STATE OF NORTH CAROLINA
DEPARTMENT OF TRANSPORTATION

Addendum No. 1
RE: Contract # C204039
WBS # 34243.3.2
STATE FUNDED
Polk County (I-4729A)
I-26/US-74/NC-108 Interchange Modifications in the Town Of Columbus

September 19, 2017 Letting

The following revisions have been made to the Roadway plans:

17-AUG-2017 10:14
I:\14729A\Roadway\XSC\I-4729A_Rdy_xpl.dgn
$$$$USERNAME$$$$

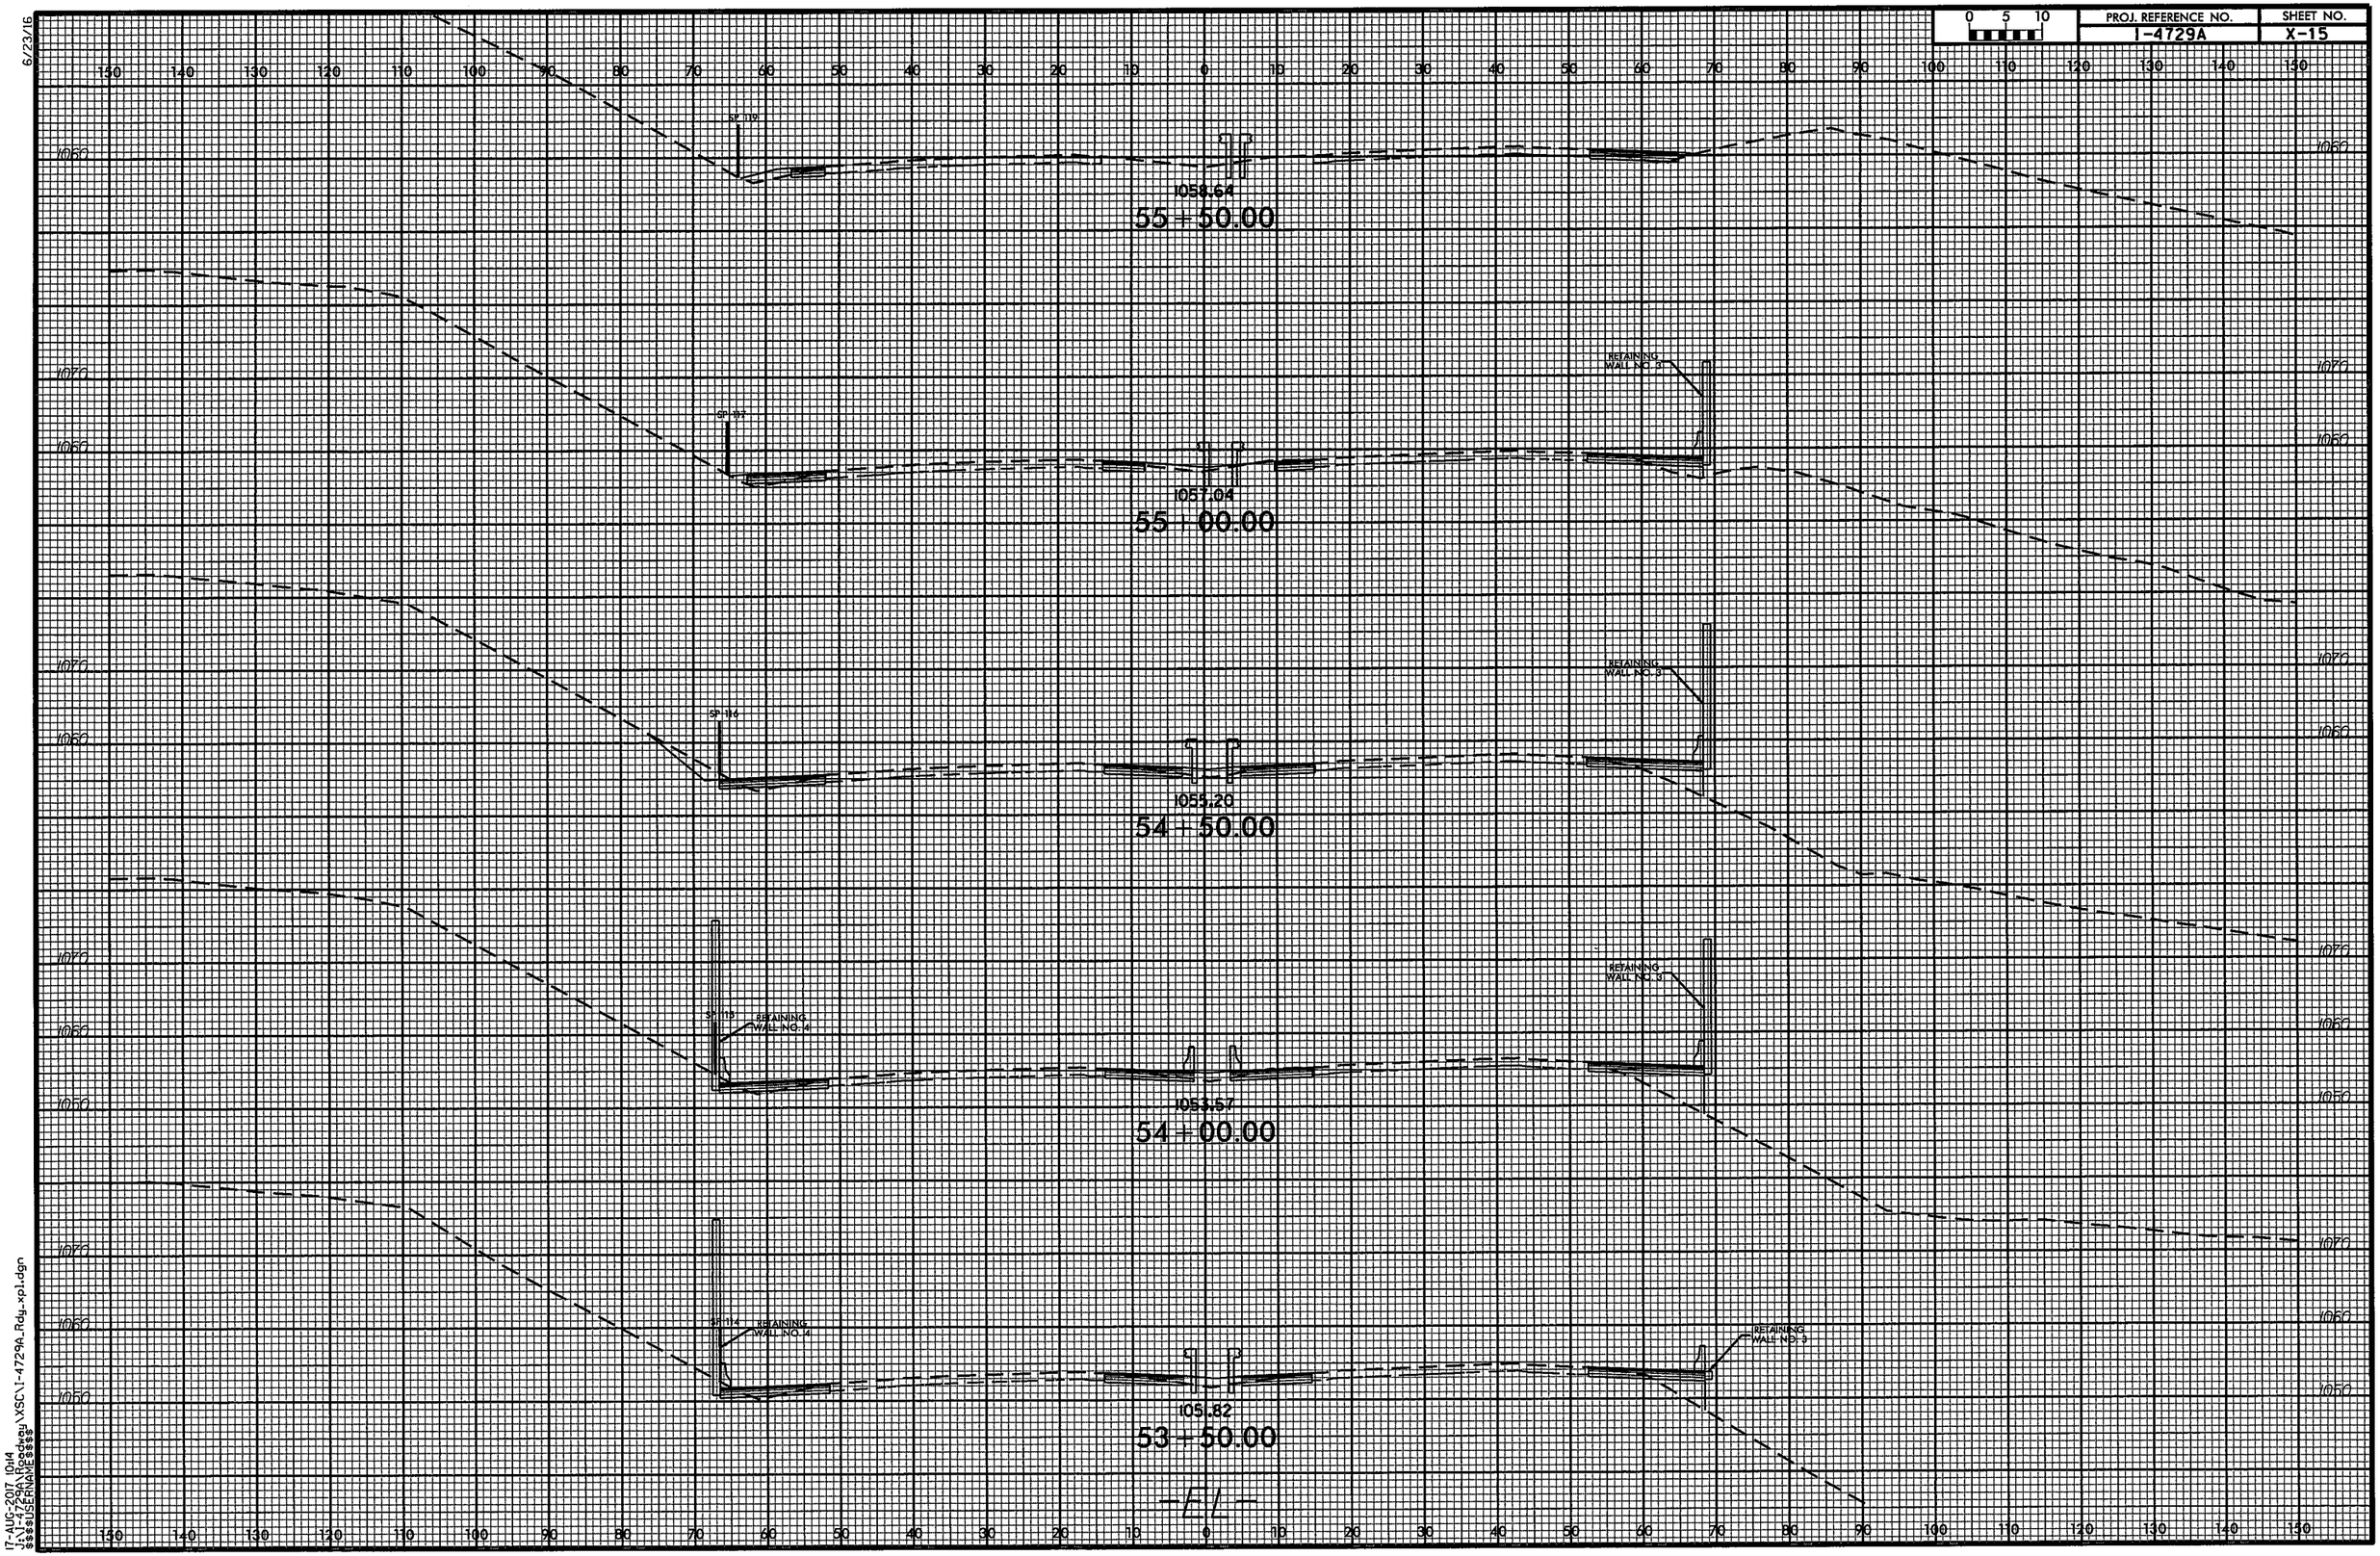
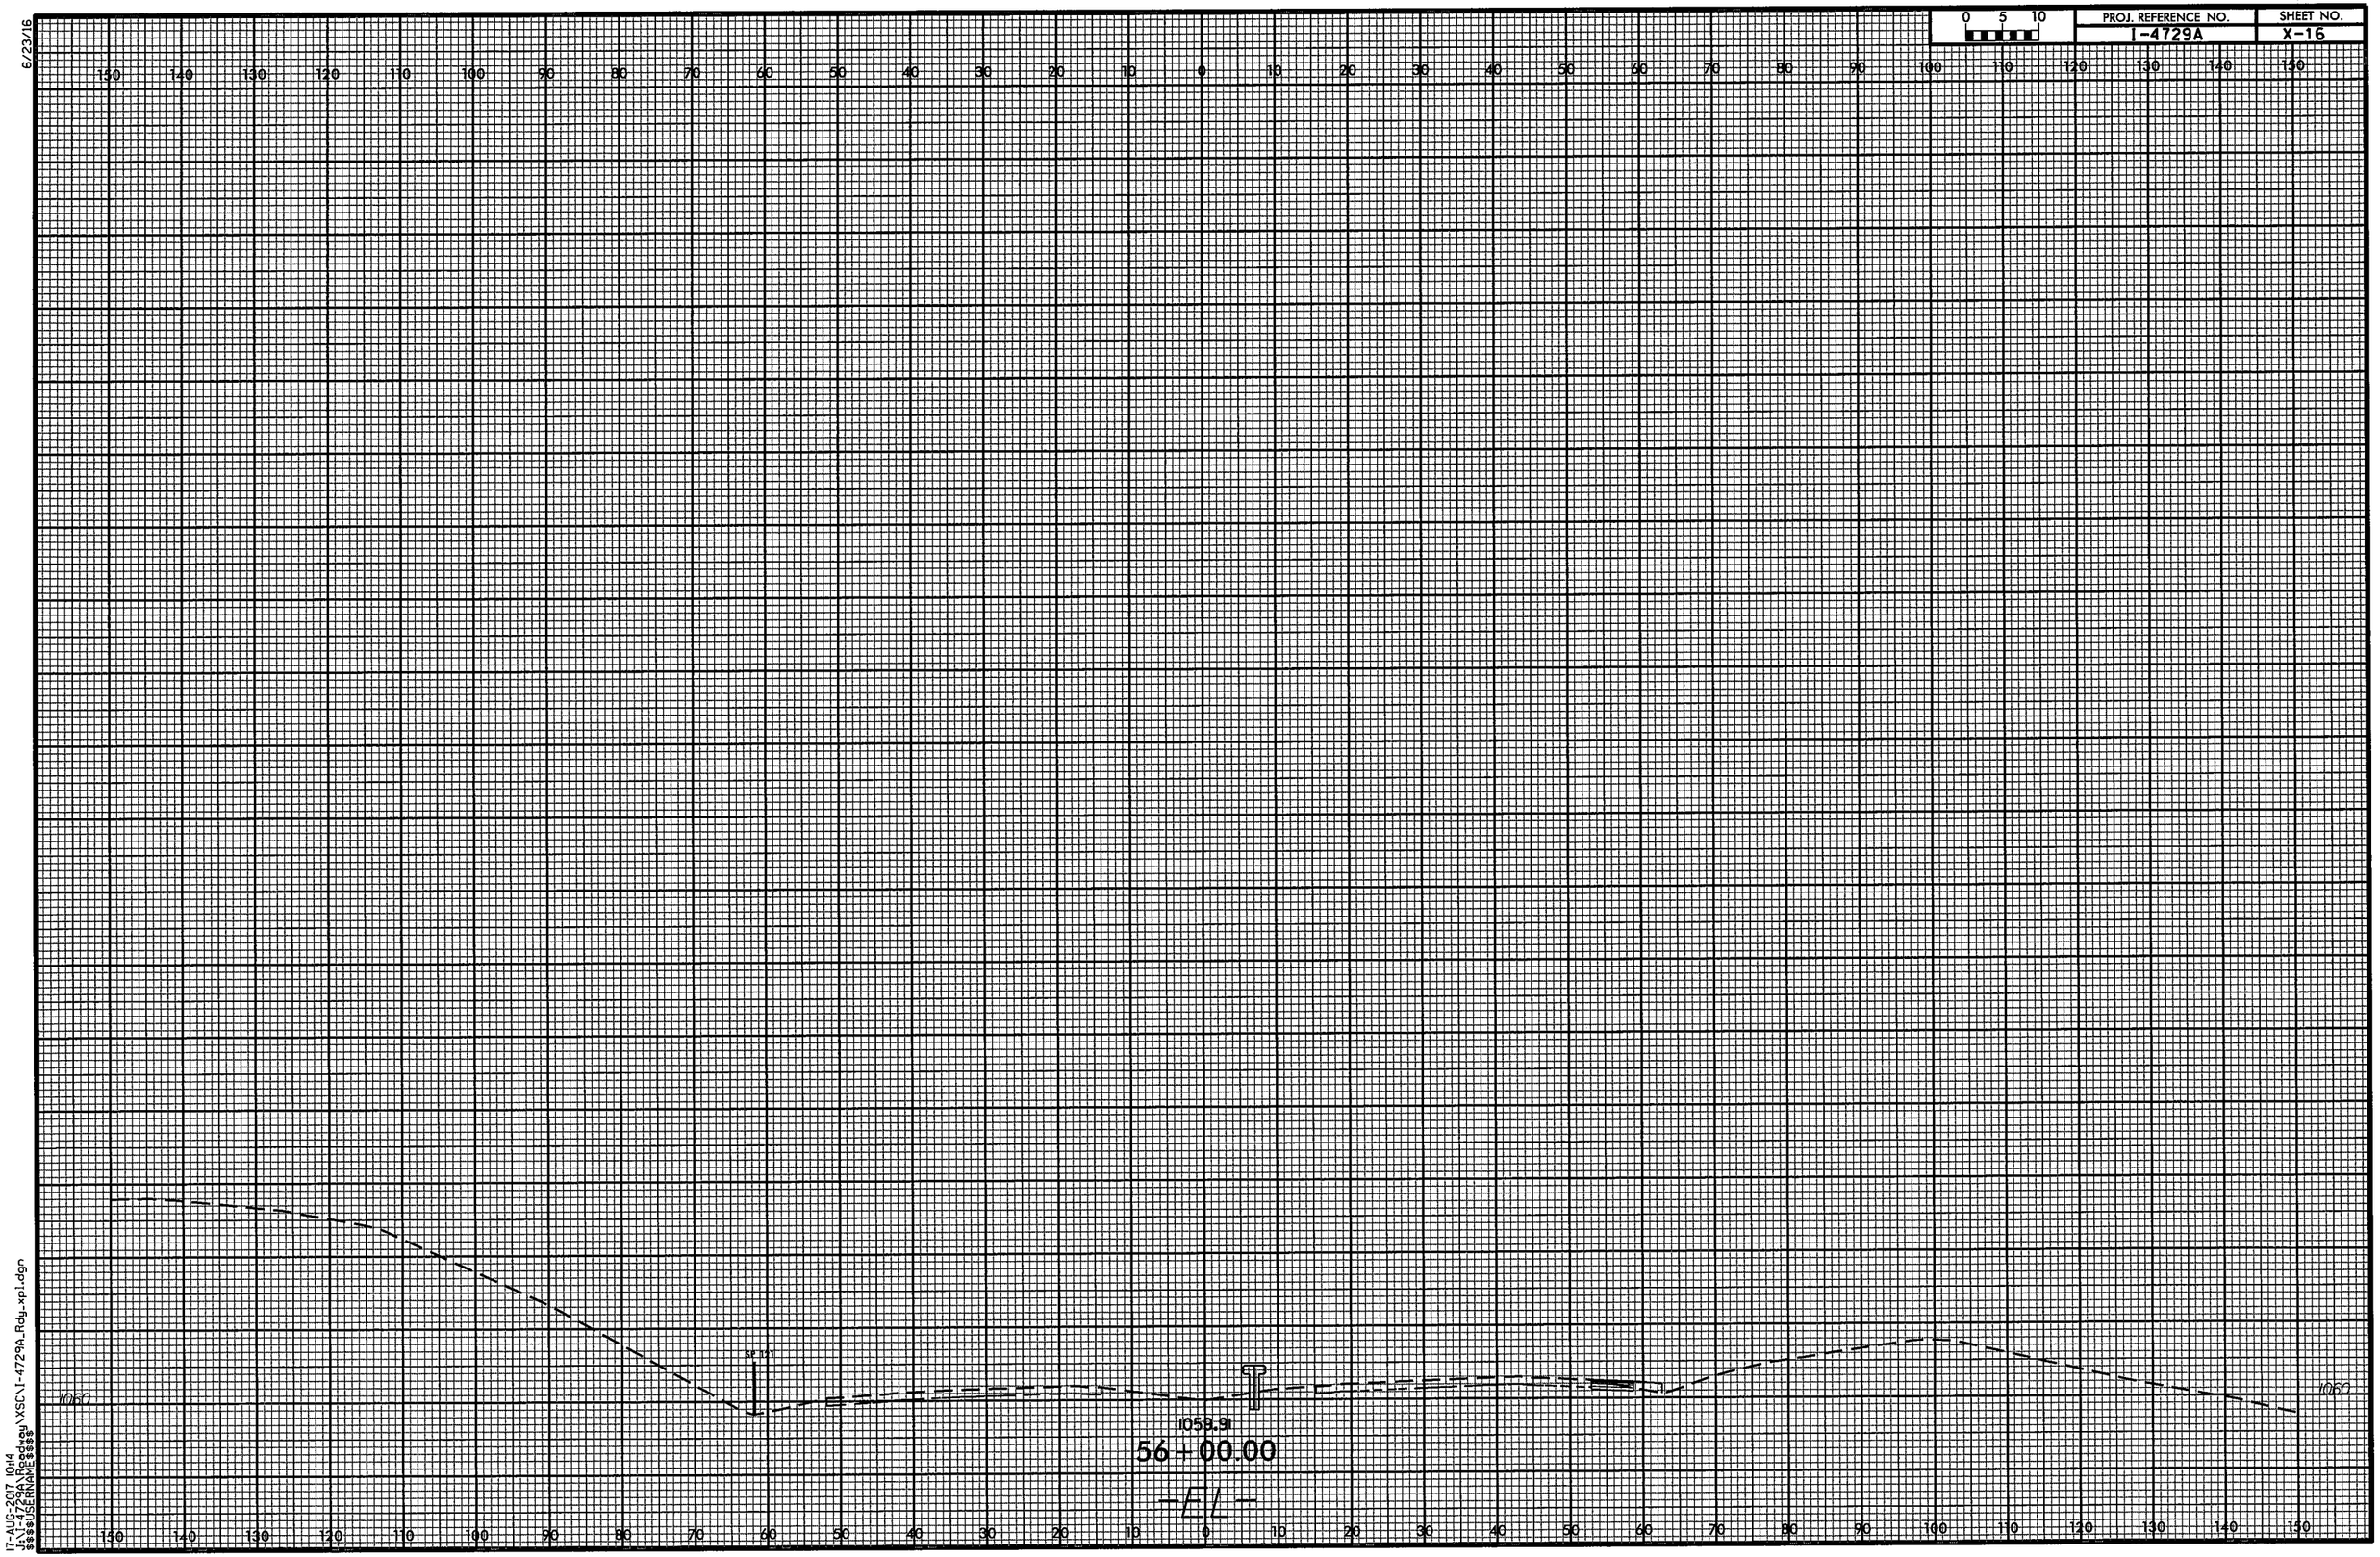
Sheet No.	Revisions
1A	Revised Index of Sheets to remove 2G-2 "Standard Embankment Monitoring Detail" and revise the number of" Drainage Summaries" sheets
2A-1, 2A-4 and 2A-5	Revised the Typical Sections for the change in mainline pavement widening design from ABC to Asphalt Base
3B-1	Revised 'Summary of Earthwork' to account for pavement widening design change
3D-1 thru 3D-4	Various drainage quantity changes as noted below
3G-1	Removed "Settlement Gauge Summary" and added note that Bridge Waiting Period only applies to Approach Slab construction
5	Revised to require Welded Steel Pipe by Trenchless method under the Interstate 26
X-1A thru X-87	Revised Cross-Sections to reflect the change in Earthwork due to the pavement design change
